# Waterline FEIS Addendum – Meliadine Mine

*Information Request Responses*

Submitted to:  
**Nunavut Impact Review Board**

Submitted by:  
**Agnico Eagle Mines Limited – Meliadine Division**

**Figure CIRNAC-IR-1a: Waterline conceptual flow diagram**

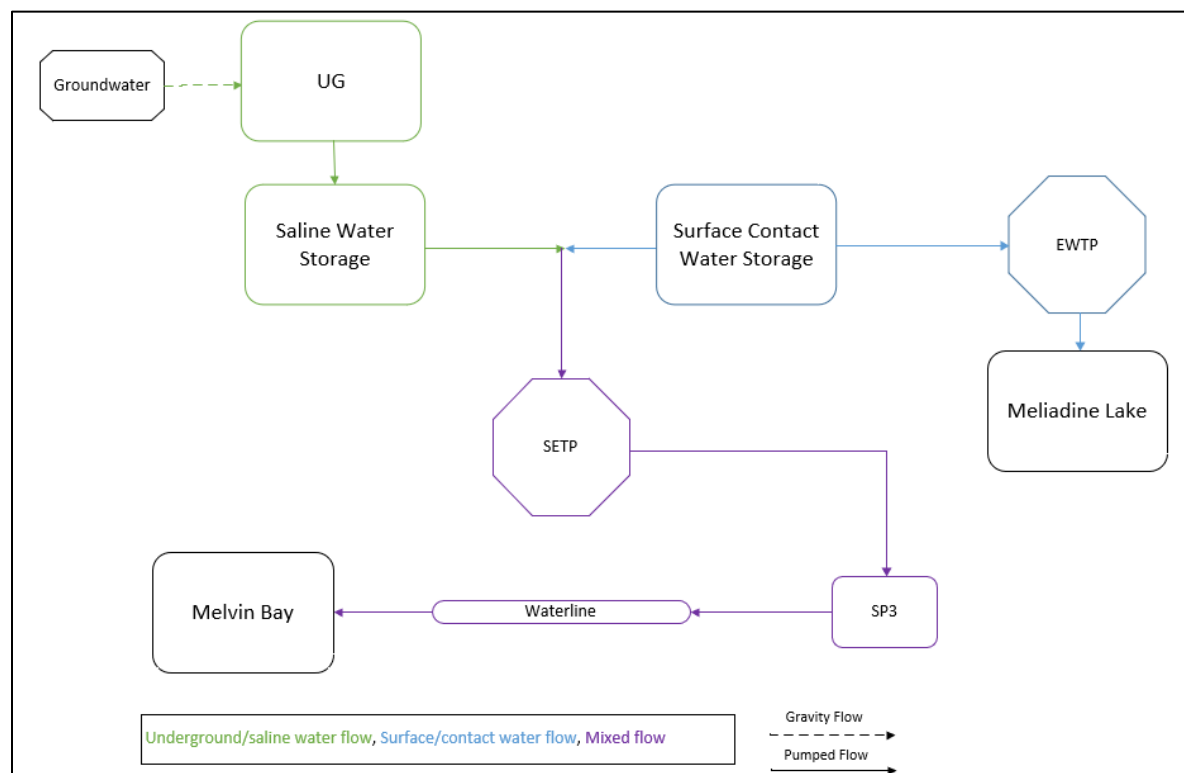
*CIRNAC requests that:*

- a) AEM confirm if only treated saline groundwater will be conveyed through the waterlines and discharged directly from the treatment facilities into the waterlines for conveyance to and discharge within Melvin Bay;*
- b) Alternatively, AEM should provide information on other additional arrangements.*

Various contact water sources at site – including Underground (Saline) and Surface Contact Water – are combined, at times, to minimize overall site footprint and to support long-term environmental management at site. The combined flows of Saline and Surface Contact Water will be pumped to the Saline Effluent Treatment Plant (SETP) for treatment prior to discharge to the waterline. The flow diagram below (Figure CIRNAC-IR-1a), adapted from the flow diagram provided in the August 2020 FEIS Addendum to include saline and contact water management, presents this concept. This flow diagram is consistent with the one presented in Saline Effluent Treatment Plant Design Report (Agnico Eagle 2020) approved by NWB on September 9, 2020.

Figure CIRNAC-IR-4b: Proposed Waterline conceptual flow diagram

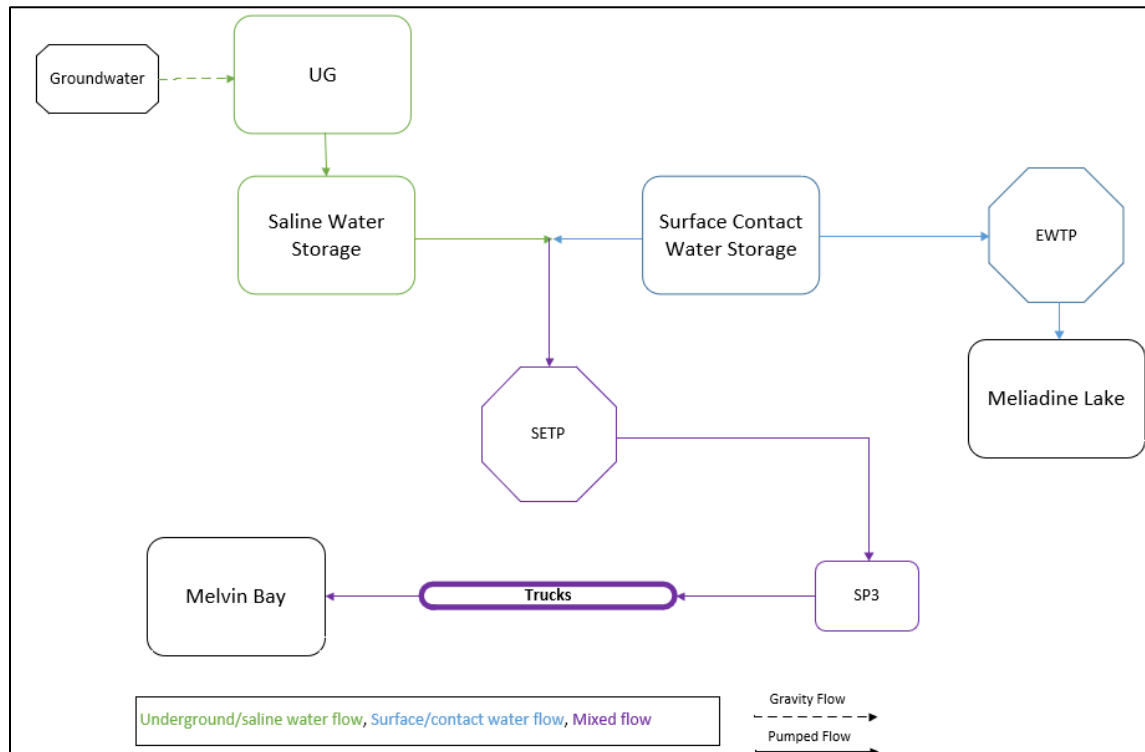
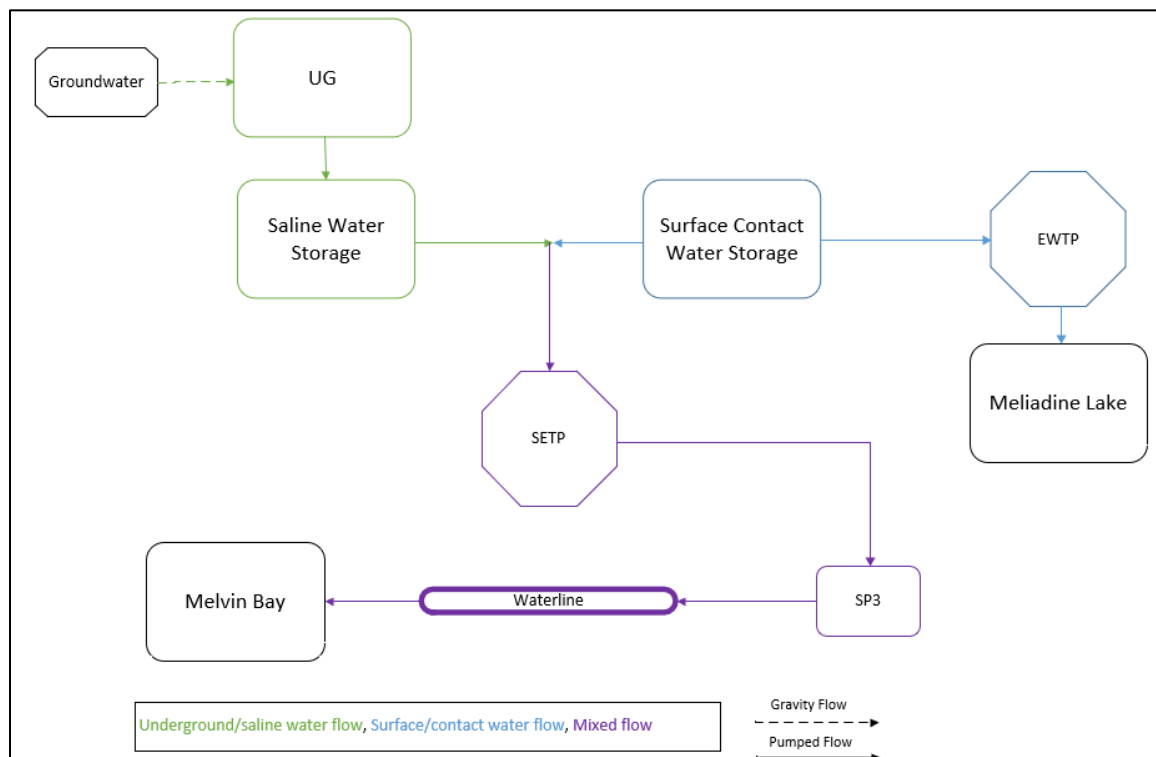
*CIRNAC requests that AEM provide a conceptual Water Quality and Load Balance Model. The model should indicate all proposed changes relative to the currently approved project.*

Agnico Eagle considers that the information provided as part of the Meliadine Saline Water Balance and Water Quality Model – Saline Water Management (Golder, 2020) fulfil the requirement to complete the assessment of the Project. The Saline Effluent Discharge to Marine Environment Project focus primary on the change of conveyance of the saline water to marine environment and Agnico Eagle does not expect change in the composition of the water quality of the effluent to the Melvin Bay as:

- No change is observed on the saline water quality stored on site;
- No change is observed on the groundwater quality reporting to the underground mine, and;
- No change on the water treatment process is proposed, only an increase in the SWTP capacity to accommodate the higher discharge volume.

The water management strategy on site has not changed: various contact water sources at site – including saline and surface water – are combined at times and pumped to the Saline Effluent Treatment Plant (SETP) for treatment prior to discharge to Melvin Bay. This is done to minimize overall site footprint and to support long term environmental management at site. What has changed is that due to higher than originally anticipated groundwater flows to the underground, more water must be managed on site, requiring increased discharge to Melvin Bay. Simplified flow diagrams of the current and proposed water management strategy, adapted from the August 2020 FEIS Addendum, are shown below to illustrate with the difference in bold.

Updates to the water volumes and water quality due to the waterline flows are described in the Melvin Bay diffuser design document (Appendix A of the August 2020 FEIS Addendum) and the saline water balance document (Appendix H of the August 2020 FEIS Addendum). The potential impacts on water quantity to Meliadine Lake are described in Appendix IR-2 of the response package.

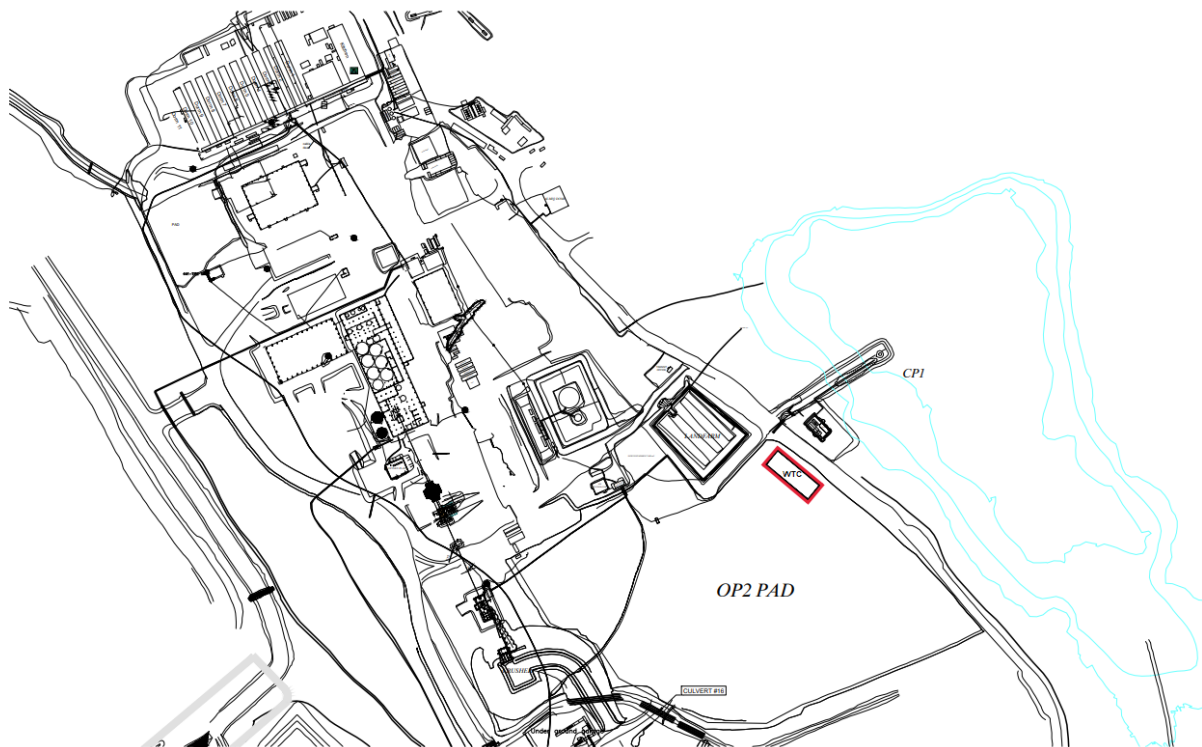
Interested Party:	NIRB	Rec No.:	NIRB-IR-002
Re:	On-site storage for saline effluent

The locations of the surface storage ponds for saline effluent, as well as the current location of the Saline Effluent Treatment Plant (SETP) are shown in the figure below.
